SUBJECT: Transmittal of Revised Westinghouse Proprietary and Non-Proprietary Responses to U.S. Nuclear Regulatory Commission Requests for Additional for the AP1000 Application for Design Certification

AP1000 DESIGN CERTIFICATION REVIEW

RAI Number: 252.001 (Revision 1 Response)

Figure 1: AP1000 Integrated Head Package and Reactor Vessel Head Elevation View

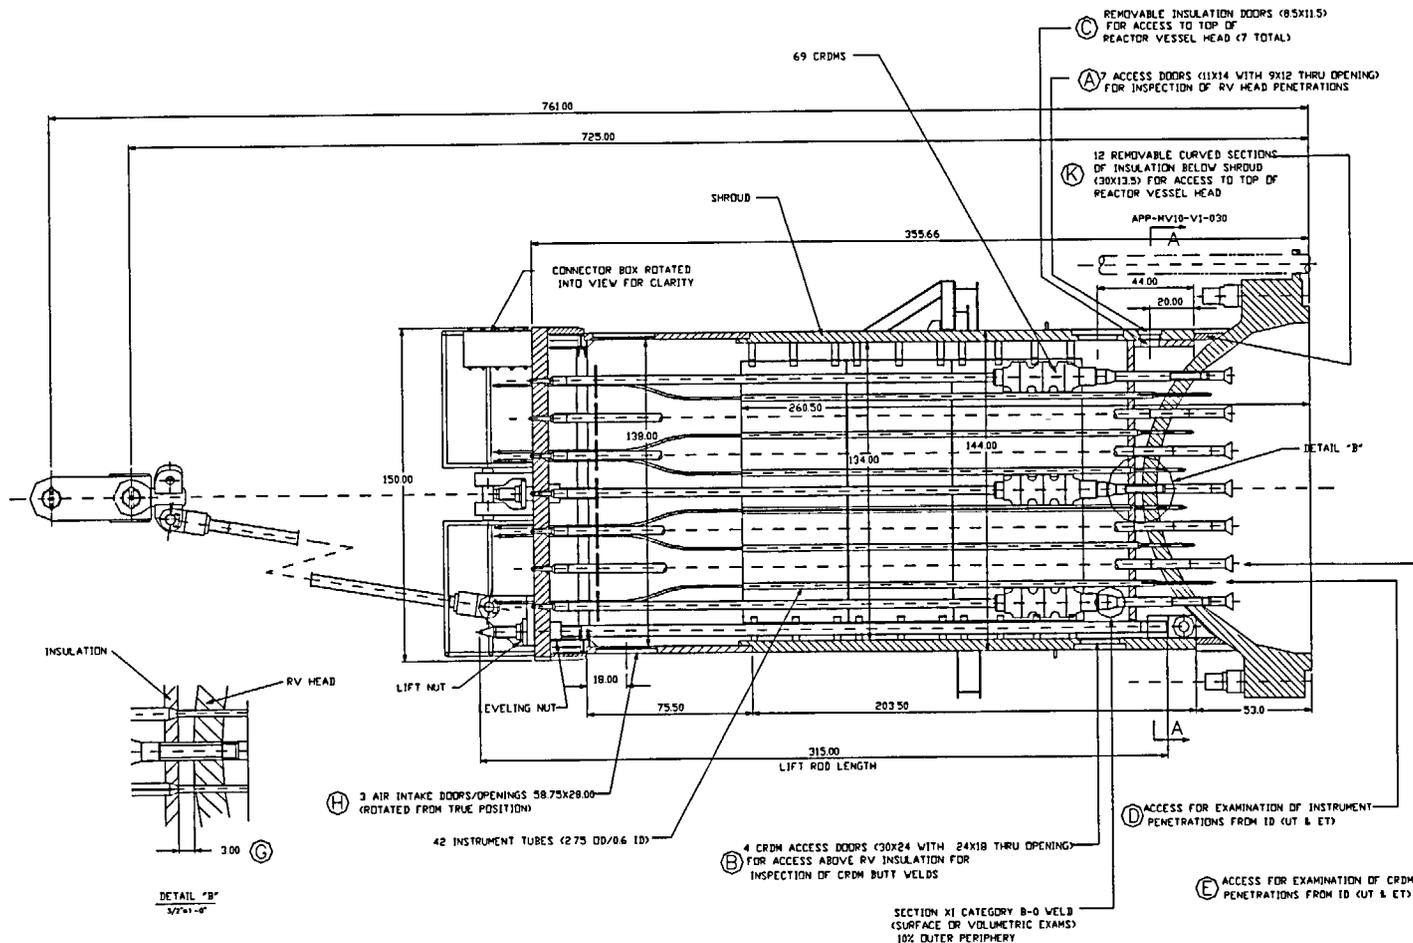
- b. Explain how the design permits for a visual examination of 360° around each reactor vessel head penetration.
- c. Provide drawing/diagrams of the integrated head package showing access, shroud, insulation and penetrations. Discuss how is the insulation fixed and the extent to which it is removable. What is the minimum offset of the insulation from the surface of the RPV head?

- c. The attached two figures are included to show the AP1000 reactor vessel head and integrated head package, and associated access features related to head inspection. Figure 1 shows a cross-sectional view of the vessel head and integrated head package. Figure 2 shows a plan view from below the head vessel insulation. These drawings are intended to show access to under the head insulation as well as to appropriate levels within the shroud above the insulation. Access doors/ports/windows/panels are identified on the drawings. The limiting access gaps are also indicated.

The seven shroud ports/insulation doors and twelve removable insulation panels ('A' and 'C', and 'K', respectively) provide direct access to the bare vessel head metal including the interface between the CRDM and instrumentation penetrations and the top of the head. The four shroud manways ('B') provide access to the lower region of the

Figure 440.162-5 WCOBRA/TRAC Simulation of OSU Test SB18
Change in Reactor Vessel Liquid Mass from ADS-4 Actuation

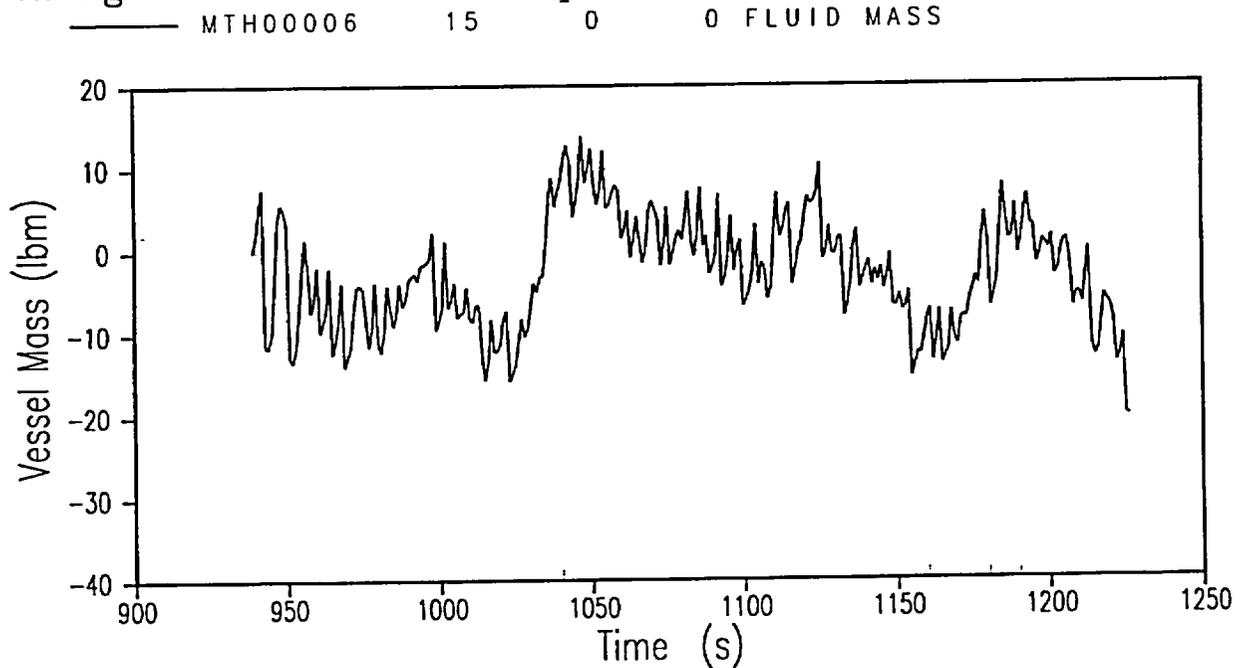
- (c) Page 2-52 describes a "detailed comparison of vessel mass inventory with the test inventory" to show that the WCOBRA/TRAC prediction is in "excellent" agreement with the measured mass reduction during the ADS-4/IRWST initiation phase. There are no Figures comparing the predicted and measured inventories for Test SB18. Please provide this comparison.

- c) A plot of the change in reactor vessel mass inventory during the Test SB18 ADS-4 IRWST initiation phase (Figure 440.162-4) is provided for comparison with the WCOBRA/TRAC prediction of this mass inventory change (Figure 440.162-5). Both the test data and the code indicate that a small decrease in the vessel mass inventory occurs by the time of IRWST initiation during Test SB18.
